Intel[®] Celeron[®] Processor Specification Update

Release Date: January 02

Order Number: 243748-041

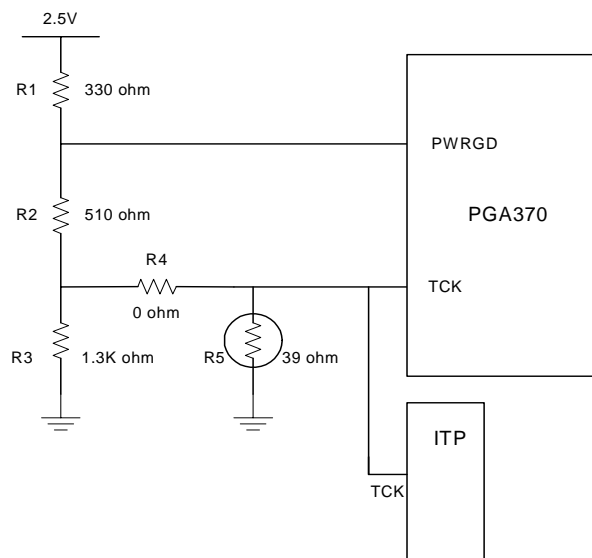
Implication: This issue can lead to intermittent system power-on boot failures. The occurrence and repeatability of failures is system dependent, however all systems and processors are susceptible to failure. In addition, the processor may fail to stop execution during the event of a valid THERMTRIP# assertion resulting in the potential for permanent processor damage.

Workaround: To prevent the risk of power-on boot failures or catastrophic thermal failures, a platform workaround is required. The system must provide a rising edge on the TCK signal during the power-on sequence that meets all of the following requirements:

- Rising edge occurs after Vcc_core is valid and stable
- Rising edge occurs before or at the de-assertion of RESET#
- Rising edge occurs after all Vref input signals are at valid voltage levels
- TCK input meets the Vih min and max spec as mentioned in EMTS

Specific workaround implementations may be platform specific. The following examples have been tested as acceptable workaround implementations.
